ISSUE "A" ADDED TO PLAN. W.P.B. 4-22-46
REISS. "B" CORRECTED TRAY RACK IN PANTRY & ADDED MIRROR OVER BUFFET, BOTH PLANS, & ADDED CROSS PORTIERS FOR M.K.T. CAR ONLY. 7-28-46 C.N.B.
REISS. "C" ADDED HAND BRAKE - W. HARTER. 7-18-46
REISS. "D" ADDED EXH. FANS IN KITCHEN & PANTRY, BLOWER INTAKE FAN ABOVE PASSWAY CEILING AT KITCHEN END OF CAR & ADDED MARKER LIGHTS AT BOTH ENDS OF CAR. 8-1-46. C.N. BEECHOLD.
REISS. "E" ADDED FLOOR COVERINGS, SIGNAL VALVES, COND. VALVES, WRECKING TOOLS & ROOF VENT. 8-23-46. R.E.A.
REISS. "F" CHANGES & NOTES ADDED IN KIT. & PAN. PER M.R.S. MAE DATED 9-3-46 & MRS. # 93 DATED 9-6-46. - 9-13-46. R. FEDDERN
DELETED FAN IN PANTRY, CHANGED "ADDED" FANS IN KITCHEN PER M.R.S. # 94. 9-16-46 C.N. BEECHOLD.

86-B-88
TRACING No.
ISSUE
PULLMAN-STANDARD CAR MANUFACTURING COMPANY
FULLMAN CAR WORKS
CHICAGO
DINING ROOM SEATING CAPACITY 36
CARPET
SUPPLY LOCKER
CREWS LOCKER
CREWS LOCKER
STEWARDS LOCKER
LINEN LOCKER
ELECTRIC LOCKER
MASONITE
SYNTHETIC RUBBER
ASBESTOS GALV. STL. FLOOR
SIGNAL FLAG BRKT.
TAIL GATE
VEST CURTAIN
MARKER LIGHT RECPT.
36'-0"
12'-9"
8'-6"

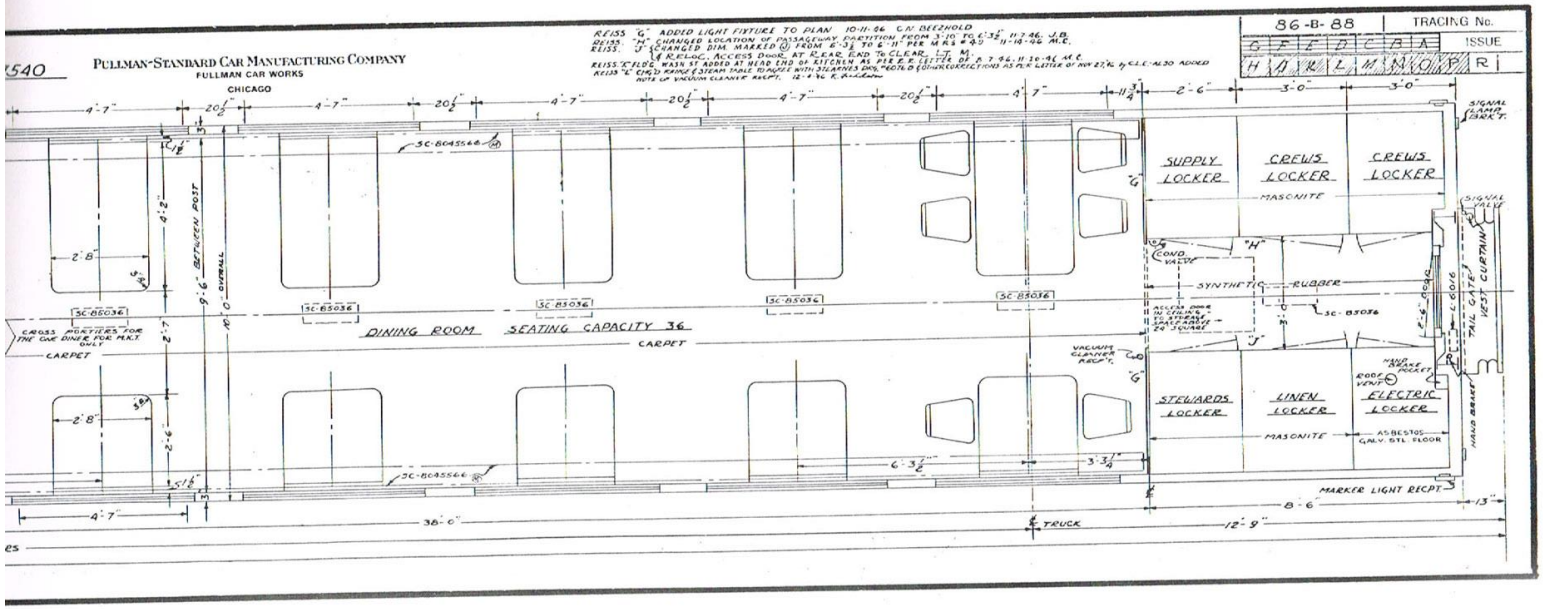
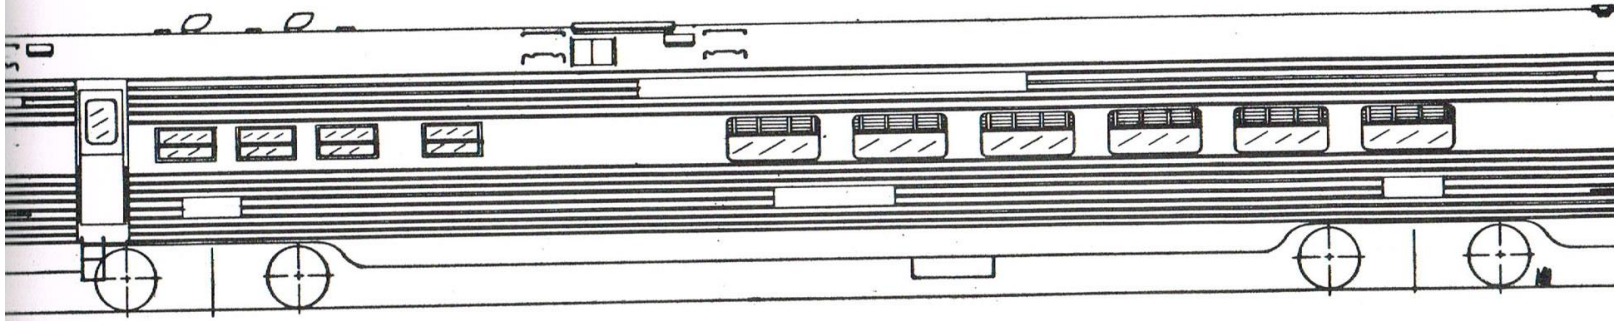
REISS. "A" CHANGED LT. FIXT. MARKED 8084 REMOVED DISH LKR. FROM ABOVE STEAM TABLE TO ABOVE SINKS. 1-17-46 W.L.M.
REISS. "N" ADDED PAPER TOWEL CABINET ABOVE FOLD'G WASHSTANDS. CHANGED LOCATION OF LIGHT FIXTURE ABOVE ICE WELL. REISS. "C" CHANGED ARRGT. OF COFFEE URN & SOUP JARS IN KITCHEN TO
CHANGED MASONITE TO ASBESTOS-GALV. STL. FLOOR IN ELECT. LKR. 2-24-47 Gang Mfg. Dept.
REISS "O" RELOC & ADDED WORK LTS IN KITCHEN & PANTRY 4-8-47 R.M.
REISS "P" ADDED DRAWING GLASS WASHING ARRGT. IN PANTRY PER MRS # 94. 7-8-47 W.Z.
